Department of Transportation

RE: Trails at Aspen Ridge_Legacy Hills Rd. / Bradley Rd. (Springs East at Waterview) - **SIGNAL review of construction drawings.**

SUBJECT: Trails at Aspen Ridge (Springs East at Waterview) - PUDSP-191
RE: Revised TIS Review and Drainage Submittals
Response to Comments Memorandum
LSC #184362

RE: Trails at Aspen Ridge Filing #2 (Springs East at Waterview) - EA-SF1927

Powers Boulevard - 60-Inch Culvert

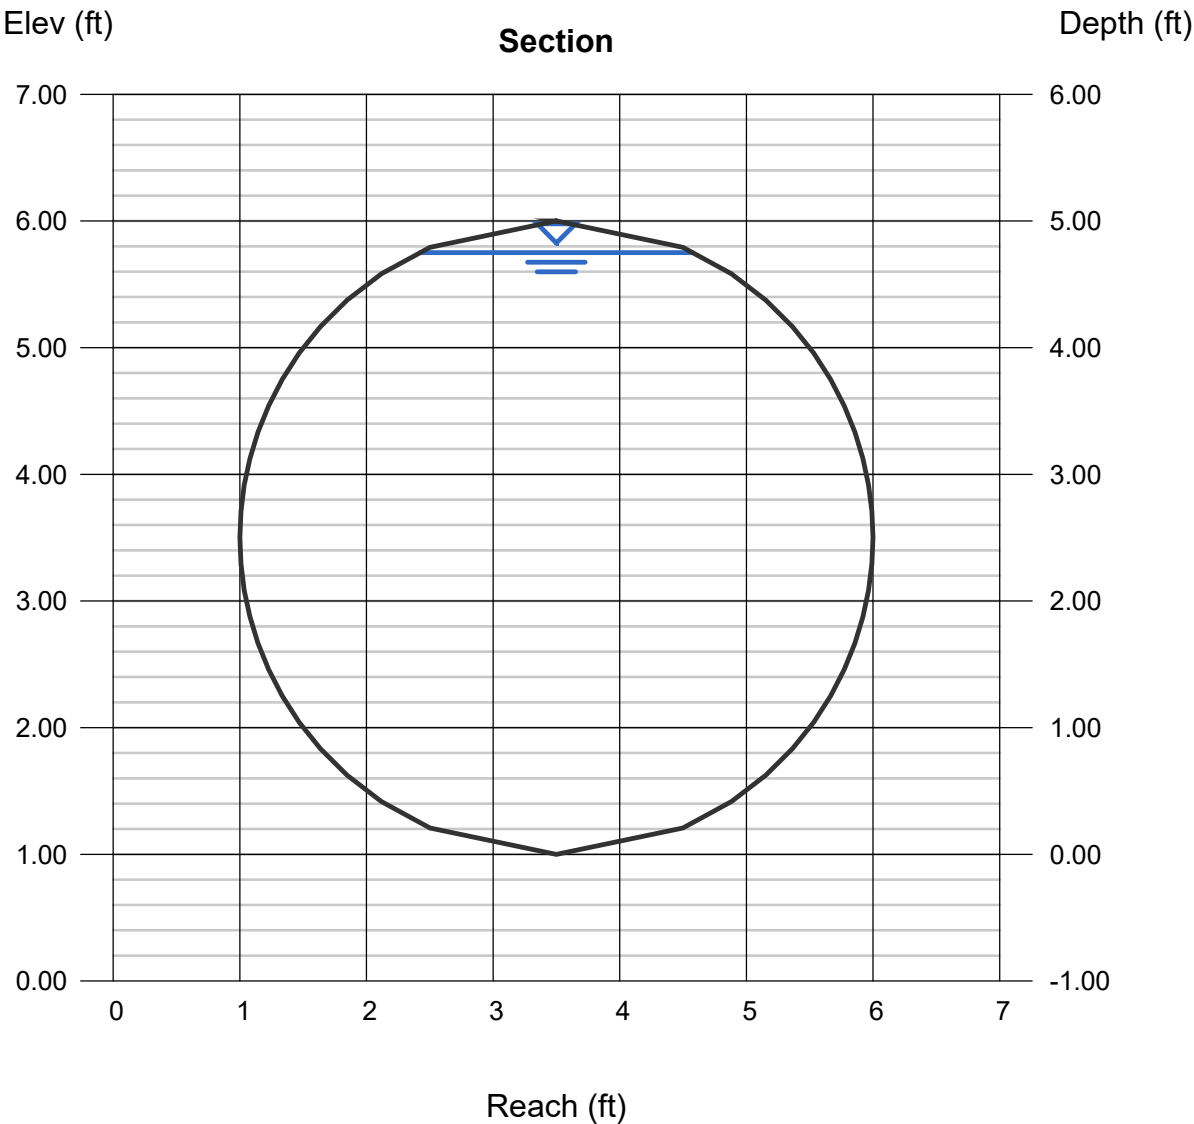
- a. Review of the Master Drainage Study dated June 2019.
- b. Please provide calculations that show the capacity of the culvert crossing Powers, and how the Pond outfall and basin that don't drain to the pond affect the capacity of this culvert.
Capacity of 60" culvert calculated to be 291 cfs. Anticipated Q100 (Equal to or less than pre development value) is 54.26 cfs.

Q (cfs) = 291.02

Powers Ditch: Total flows including Ultimate West Pond Discharge

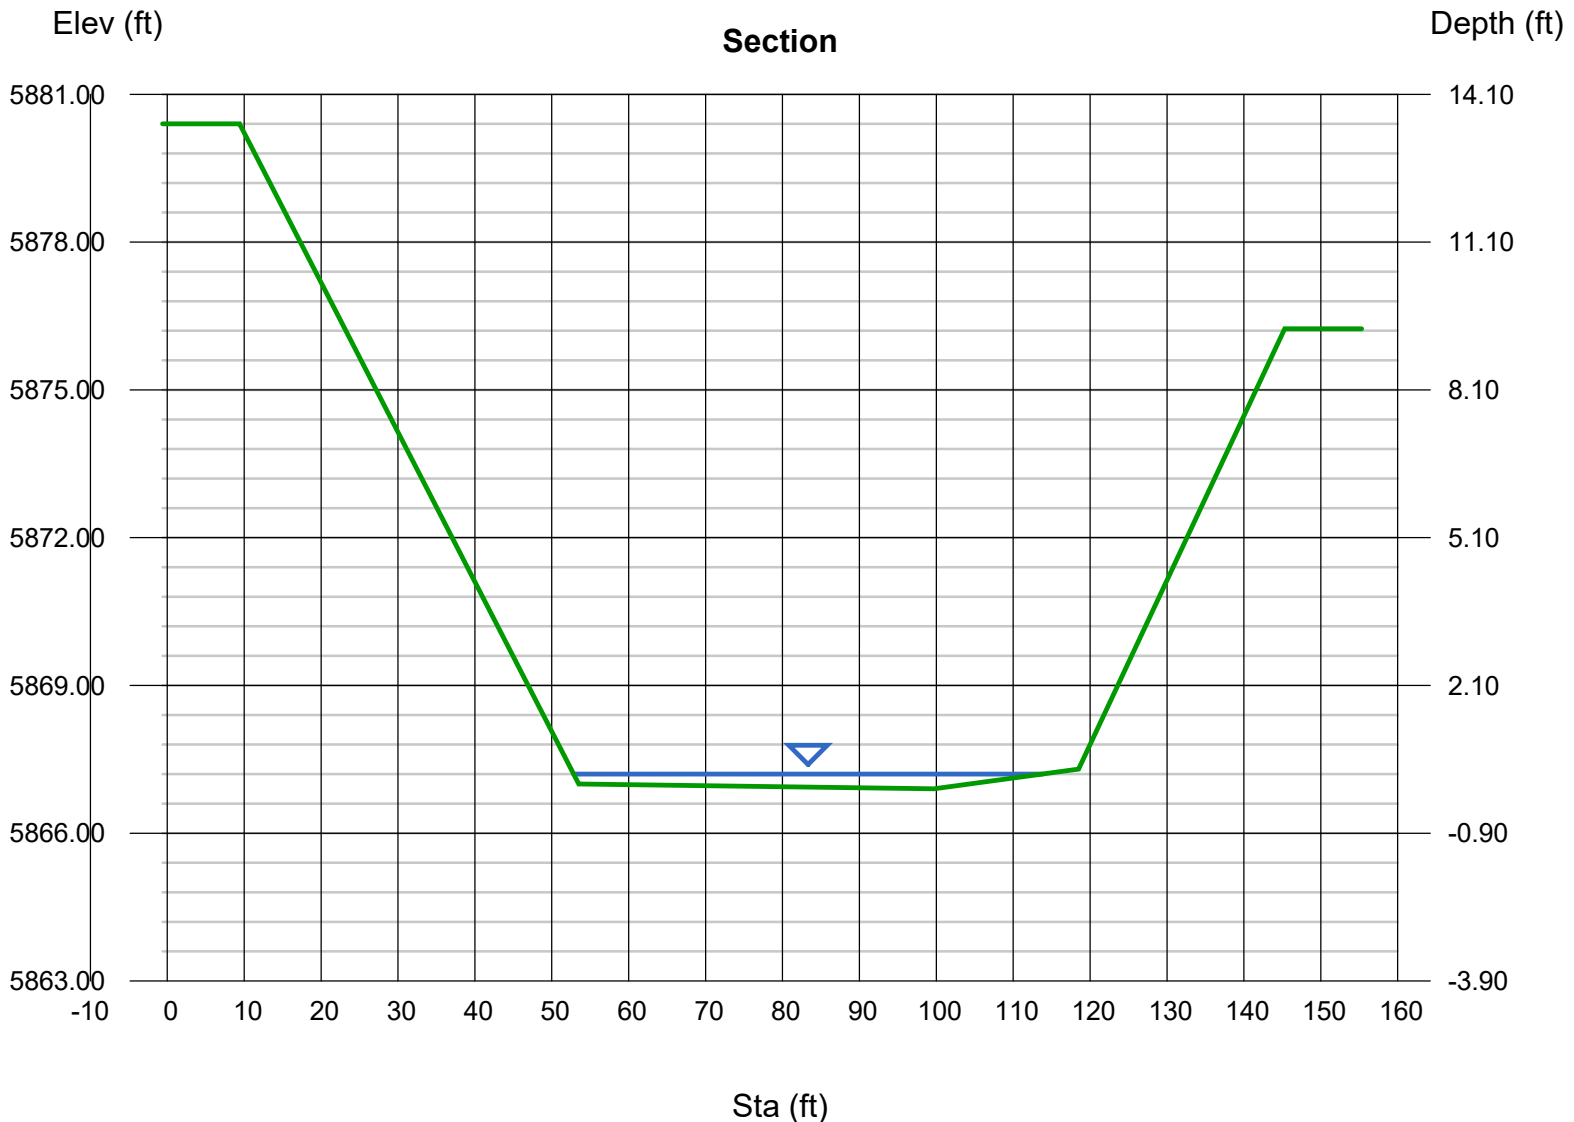
- f. Previous comments on the Powers culvert capacities and minor flow cleansing velocity have not been addressed underlined above. Please provide calculations showing that the CDOT drainage infrastructure is not affected by this development. Include hydrology showing existing vs. proposed overall basin area tributary to culverts crossing under Powers as well as hydraulic analysis of each culvert.

The west side of the project drains to the Powers Boulevard Ditch. The flows cross Powers Boulevard at a 60-inch culvert adjacent to the West Pond and at a 48-inch culvert near the southwest corner of the site. Flows within these two culverts remain in compliance with CDOT requirements. See Table 8.5 Below:

Powers 60-inch Culvert - Minor Storm Event

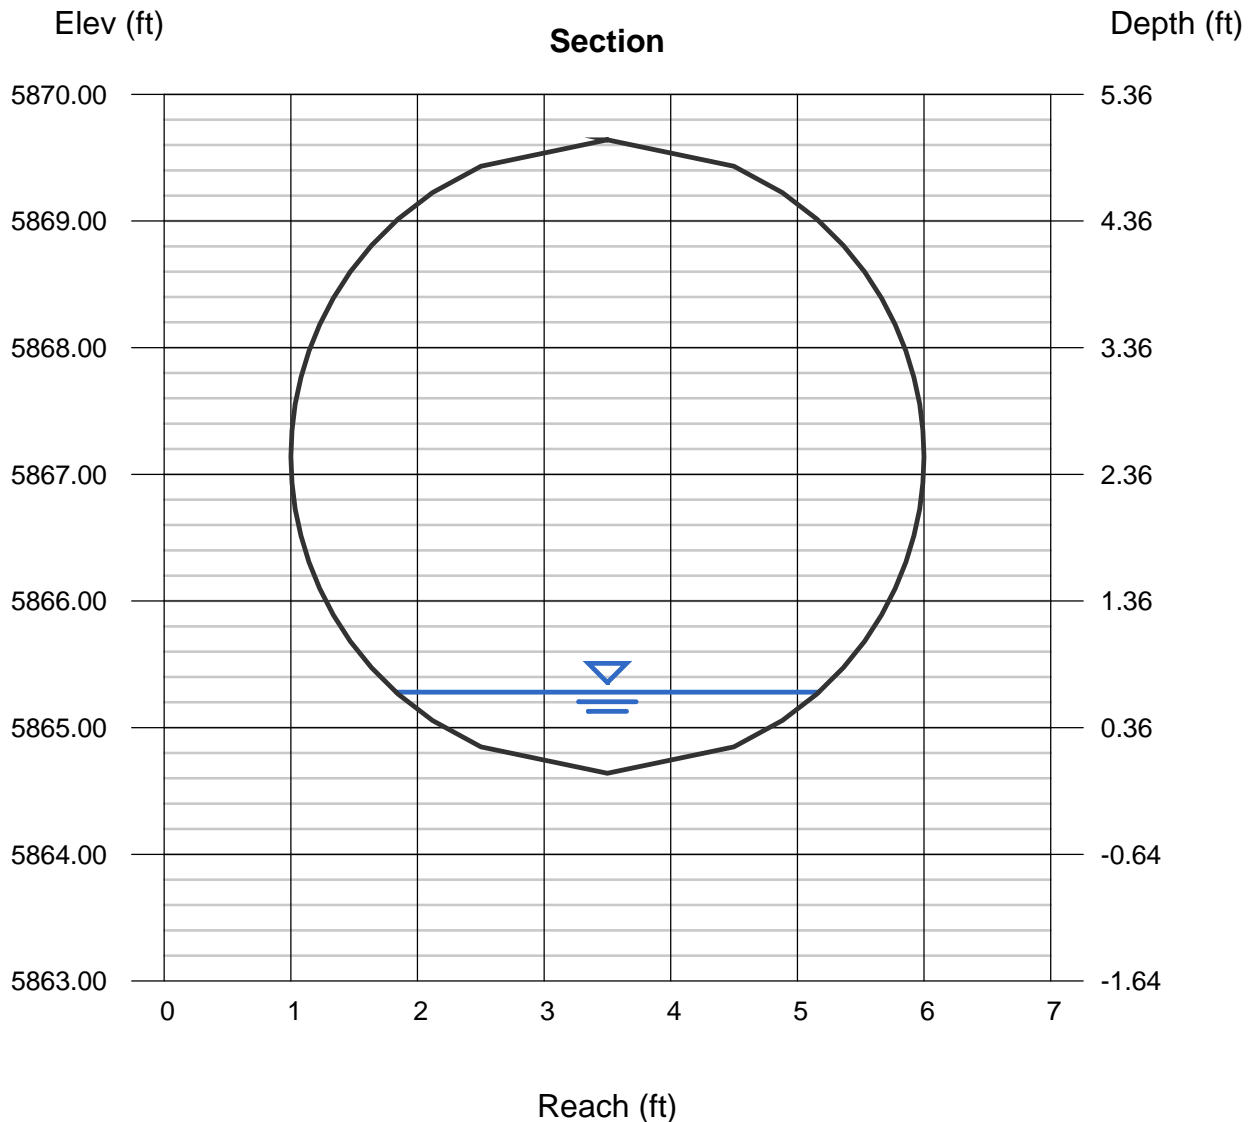
- d. Also, the 60" culvert needs to be checked that minor storm event flows will produce velocities high enough to provide self cleaning velocity, per CDOT requirements.
Anticipated velocity of 6.4 ft/s for Minor Storm which complies with CDOT requirements.

Velocity (ft/s) = 6.37

CDOT Drainage Design
Manual, Page 9-20:
Minimum Velocity for
Minor Event = 3 ft/s

Powers 60-Inch Culvert - Major Storm Event

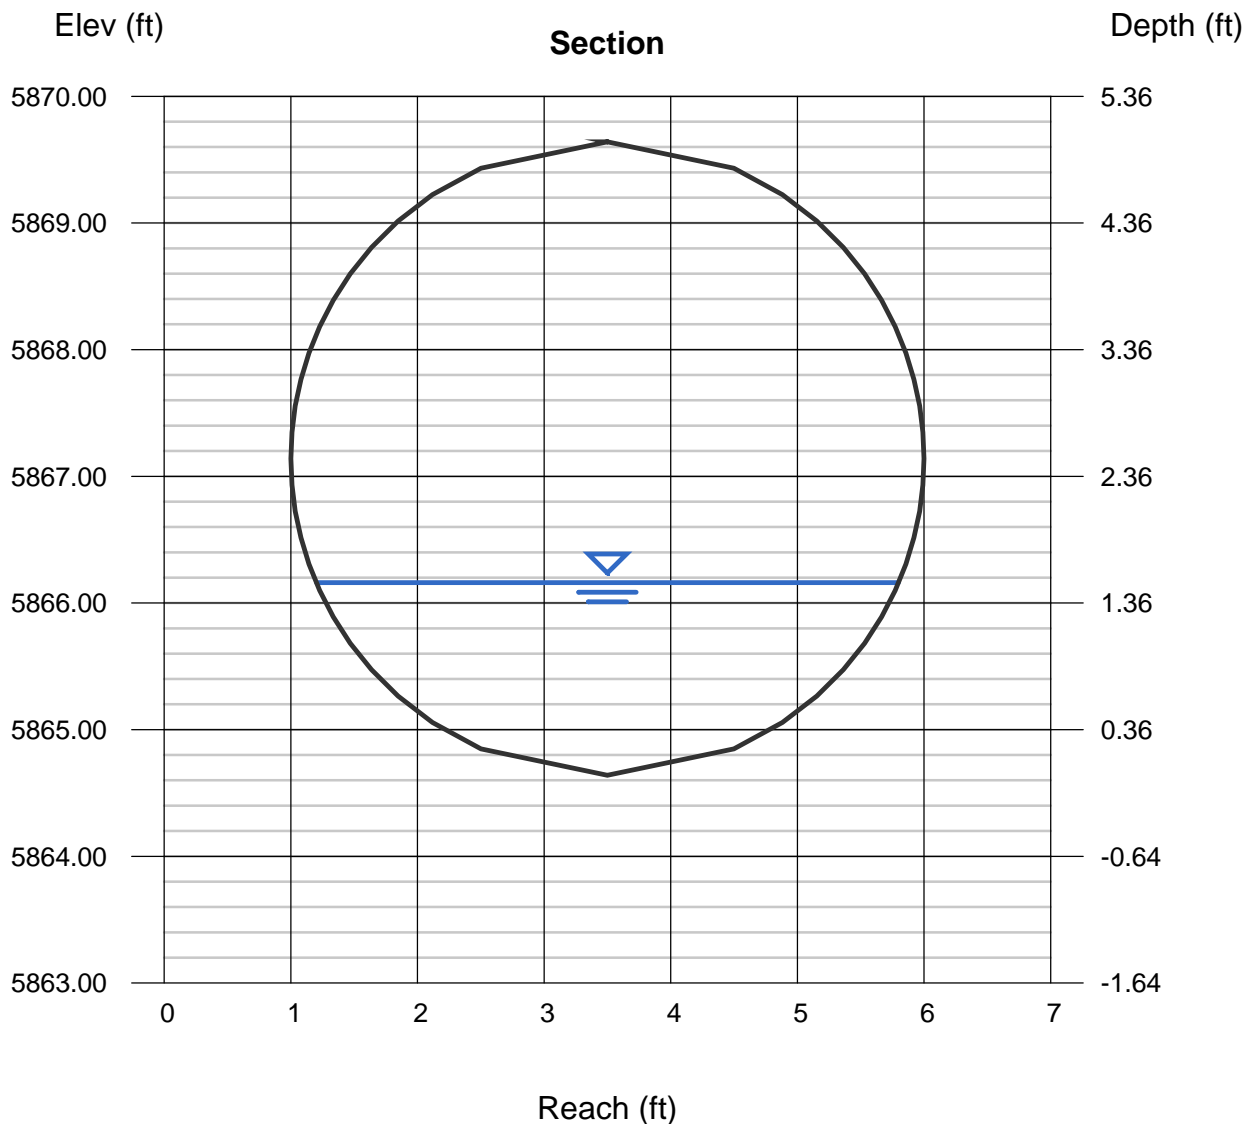
- c. It looks like the southern portion of the Big Johnson Basin is draining south to the existing 48" culvert in the existing condition. Please verify that changing the drainage patterns by capturing and conveying runoff from this area to the detention pond and then to the 60" culvert doesn't cause issues downstream.
See below.

Note: Maximum Discharge (54.26 cfs) to the Powers Ditch will be slightly lower than the estimated pre-project value of 59.6 cfs (Based on a 44.9 Acre Tributary Area).
No downstream issues are anticipated.
